RE: Supplemental Response to the Department's November 30, 2022 Request for Additional Information Related to the PA Waste, LLC Municipal Solid Waste Application for the Camp Hope Run Landfill Permit No. 101719; APS 944978; AUTH 1189259

Lisa D. Houser, P.E.
PADEP
Camp Rattlesnake Proposed Access Road
Supplemental Response
July 26, 2023
Page 2 of 2

CAMP RATTLESNAKE ALTERNATIVE **ACCESS PATH PLAN**

Compliance Plus Services, Inc.'s Exhibit E-2.1B Camp Rattlesnake Facility Boundary

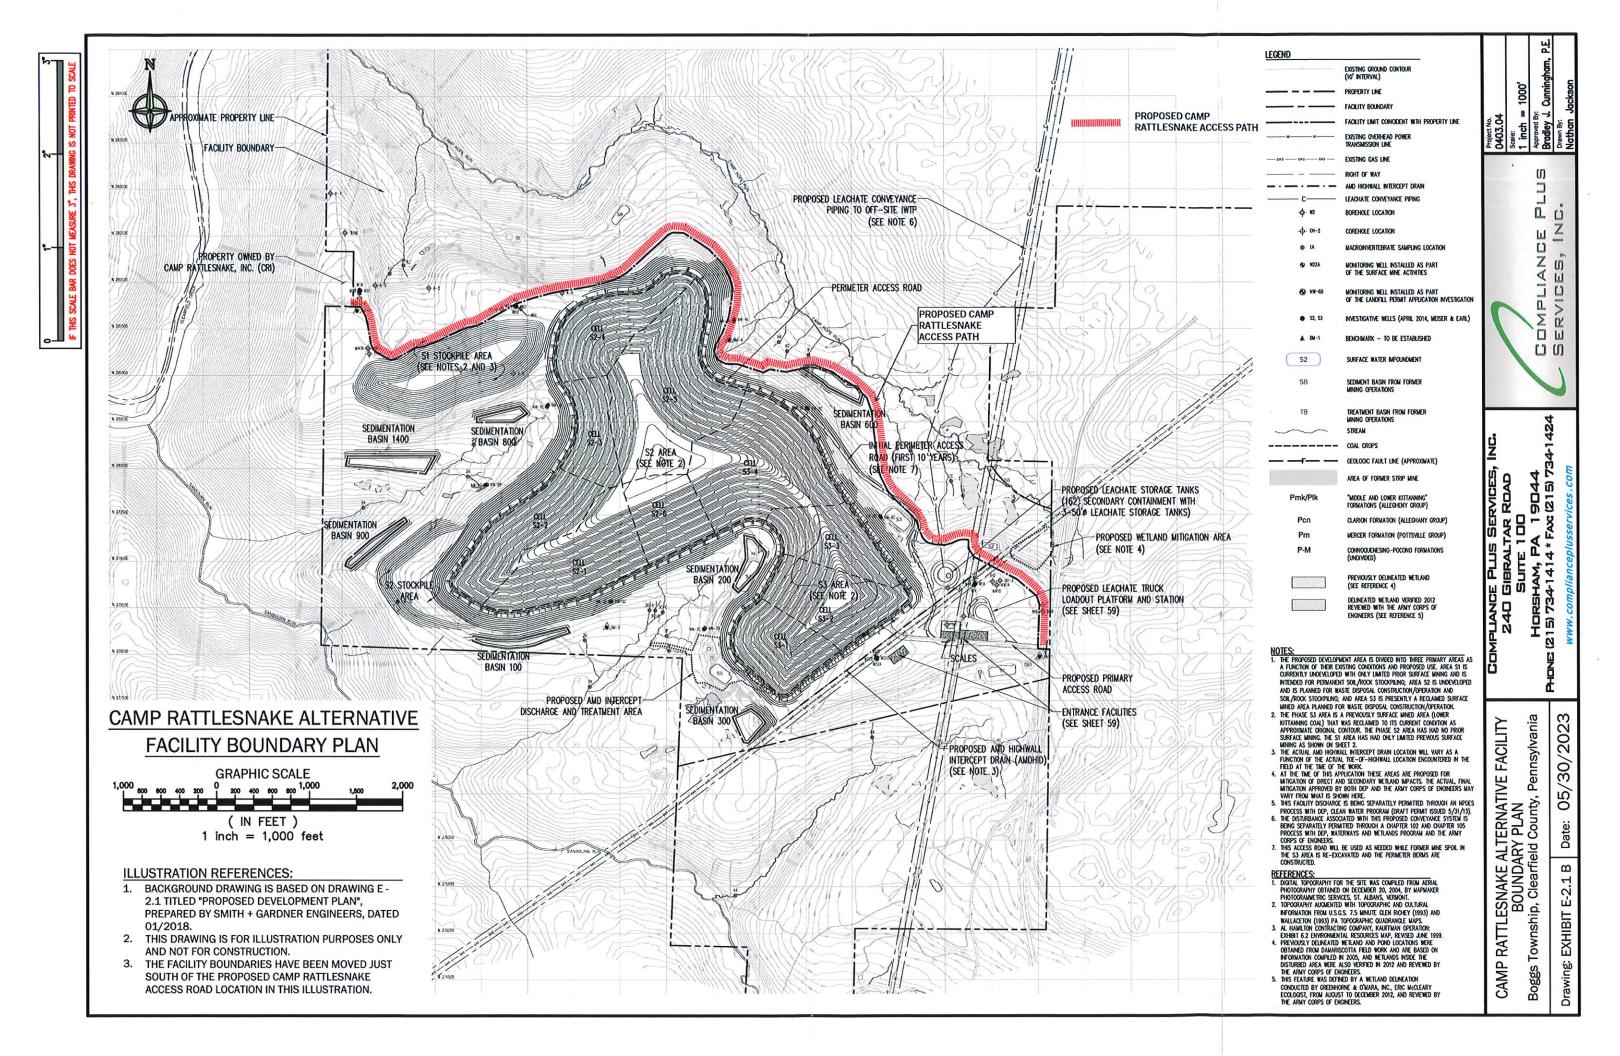
gate, the same entrance to the Camp property (see in Exhibit 1), and will be outside of the permitted area. Access to the landfill permitted area will be controlled in accordance with the Department's permitting requirements under 25 Pa. Code Chapter 273.

Compliance Plus Services, Inc.'s
Construction Plan Figure
Figure 2

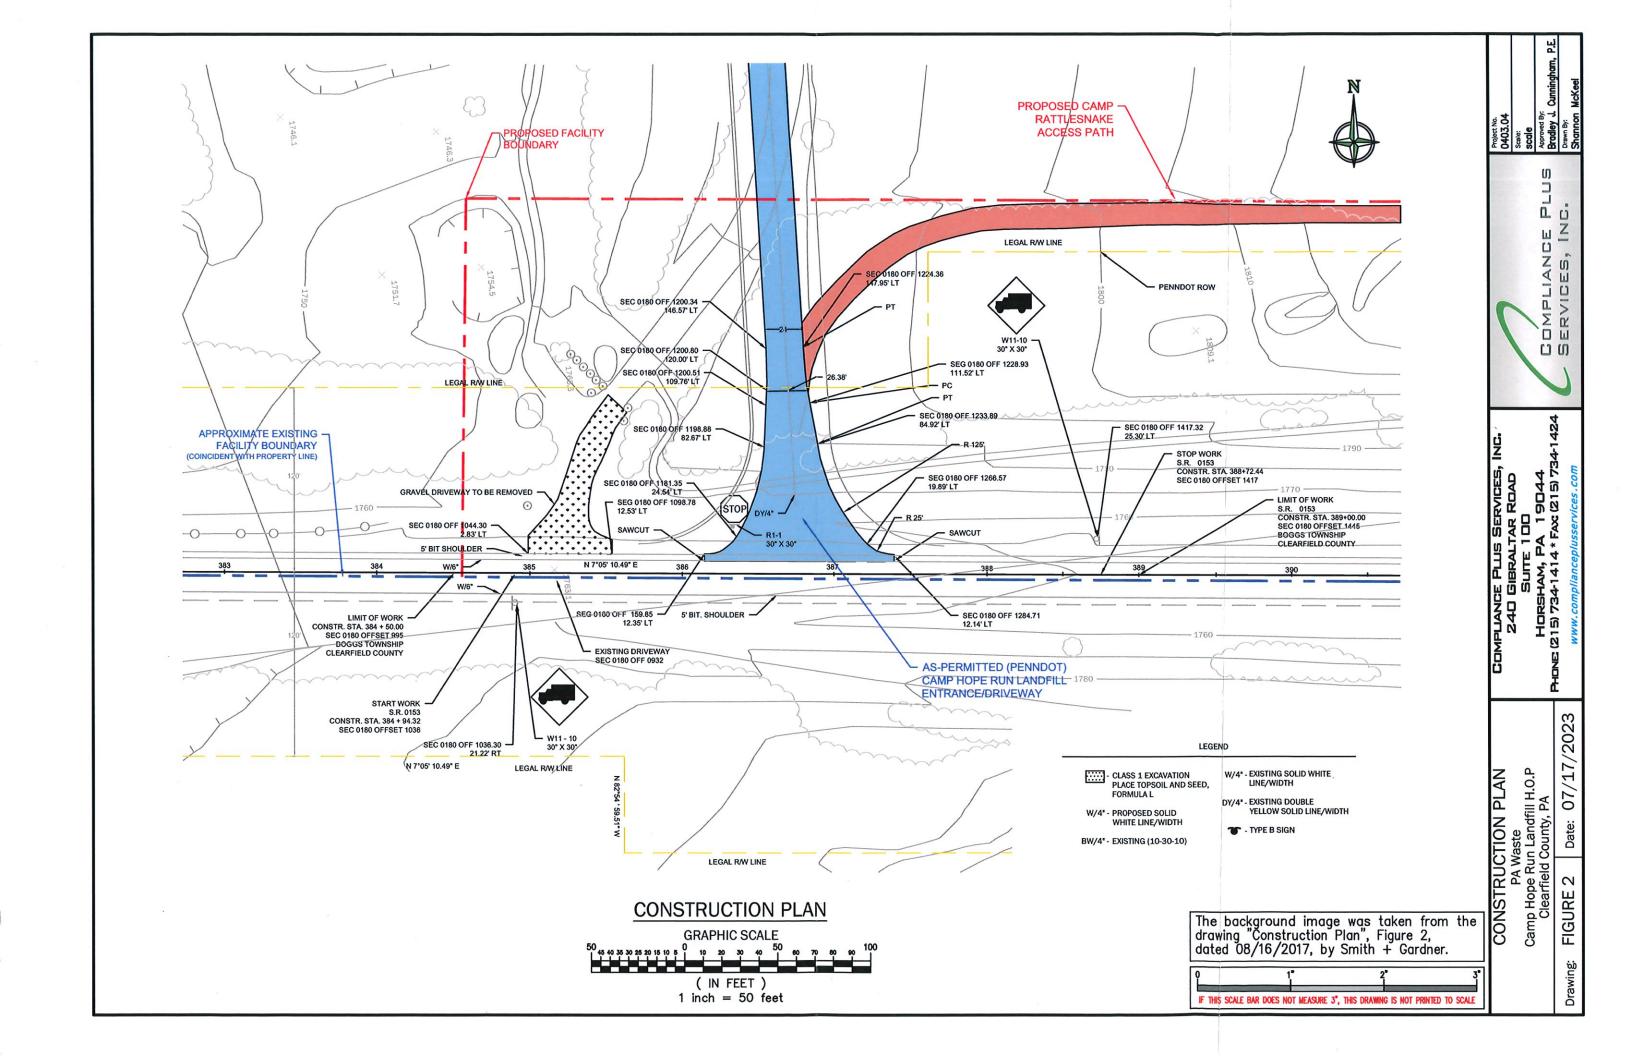
Camp Rattlesnake and the Camp Hope Run facility will effectively have the same ingress/egress from Route 153, as shown in the conceptual Figure 2 depiction that is provided in Exhibit 2 of this submission. Following that short ingress/egress road, the facility will maintain a dedicated gate and primary access road into its site area. Camp Rattlesnake's access will be adjacent to that area but will not be limited by the facility site control features. The dedicated alternate access that would be provided for Camp Rattlesnake follows a path that is similar to one of the surface mining trails previously identified on the July 20, 2019 Drawing No. S1, Existing Site Conditions (labelled on Drawing S1 as "Existing Access Roads"). For the purpose of illustration, we have included as Exhibit 3, a drawing that shows this existing approximated access pathway alongside of the proposed alternative access path.

Compliance Plus Services, Inc.'s E-2.2B Camp Rattlesnake Access Path

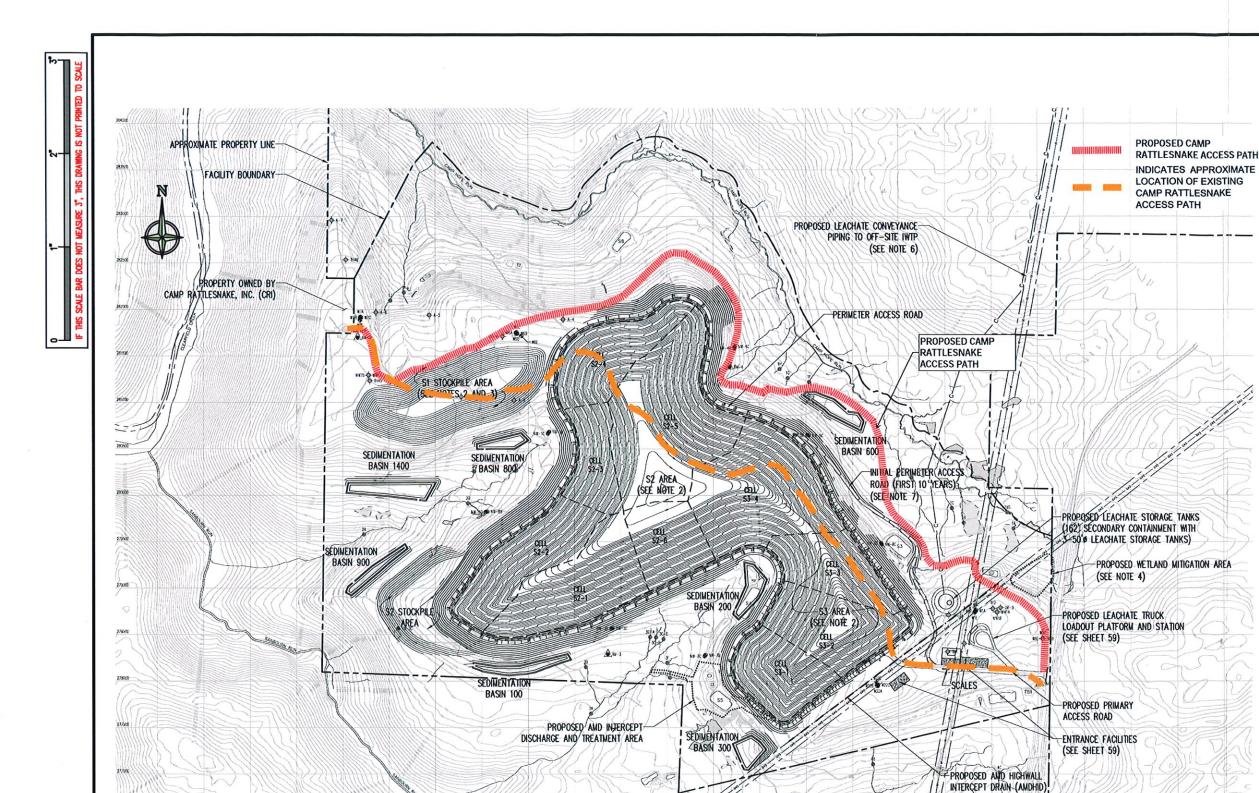
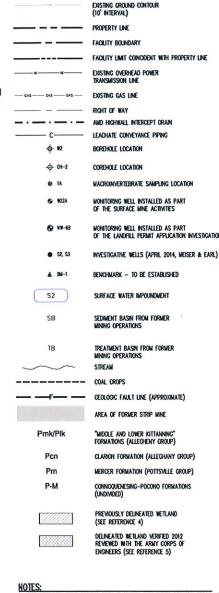
This new design will mean that the Camp's access to its property will not be impacted or limited by the operation of the landfill - i.e., that Camp Rattlesnake will be in no way landlocked or otherwise prevented from accessing its property through the same property entrances that it currently has.
